UNITED STATES PATENT AND TRADEMARK OFFICE

Office Action Summary	Application No.	Applicant(s)
	10/744,006	KIM, KEUN-CHUL
	Examiner Hilary Gutman	Art Unit 3612

DETAILED ACTION

marked-up copy
特開2002-250388

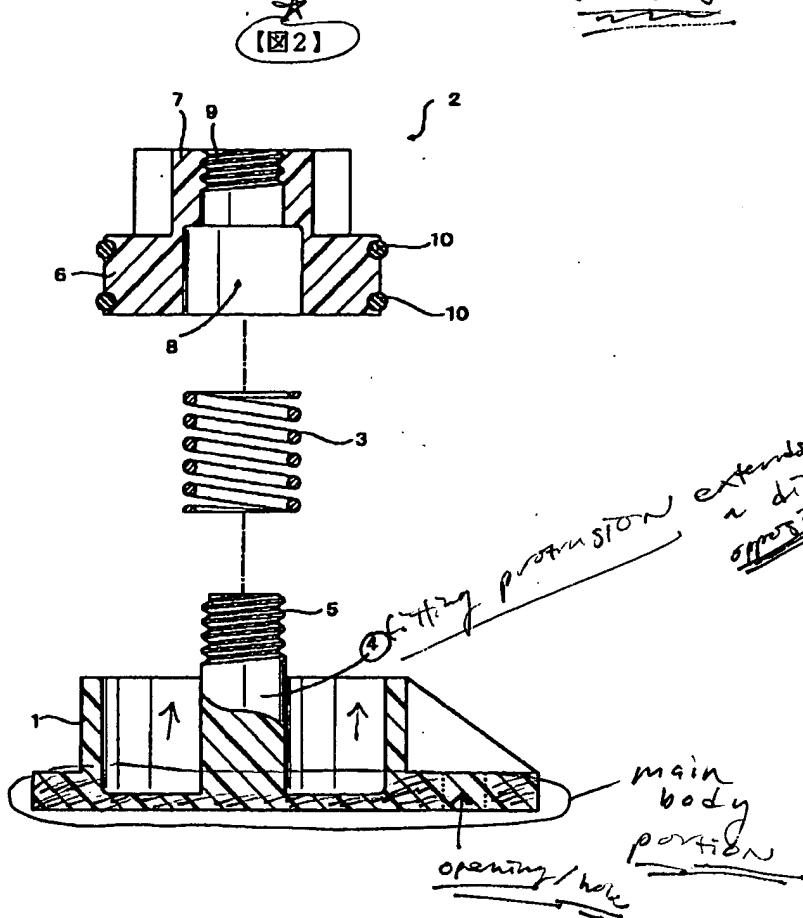
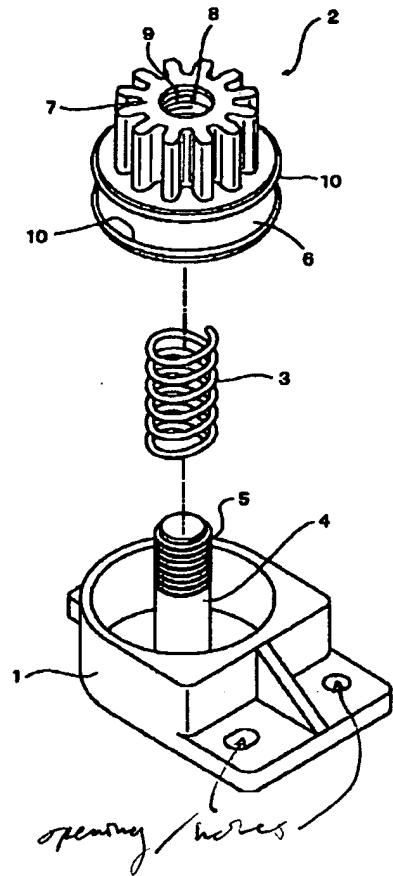
JP '388 discloses a damper assembly of a glove box (B1), comprising: a fixing member 1 (see marked-up copy of Figure 1) including a main body, wherein the fixing member is fixed to the rear part of the glove box (Figure 4) inherently by screws (not shown, but capable of passing through two holes, best seen in Figure 1), the fixing member 1 having a fitting protrusion 4 formed unitarily and in one piece with the fixing member at one side of the fixing member, wherein the fitting protrusion 4 extends in a direction opposite the main body (see marked-up copy of Figure 2); and a damper 2 having a fitting piece 7 extending from one exterior side thereof, the fitting protrusion being rotationally fitted in the fitting piece of the damper so that the damper is fixed to the fixing member.

The damper assembly further comprises a main body of the fixing member 1 having a substantially rectangular prismatic shape and being formed integrally with the one side with which the fixing member is formed; and one planar support brace (not numbered) formed integrally with the fixing member and orthogonal to both the one side of the fixing member and

the substantially rectangular prismatic shape of the main body of the fixing member. The damper is an air damper configured to contain air in an interior of the damper.

JP '388 lack the fixing member and damper being made of a plastic material.

setting protrusion extends in a direction opposite to the main body piston
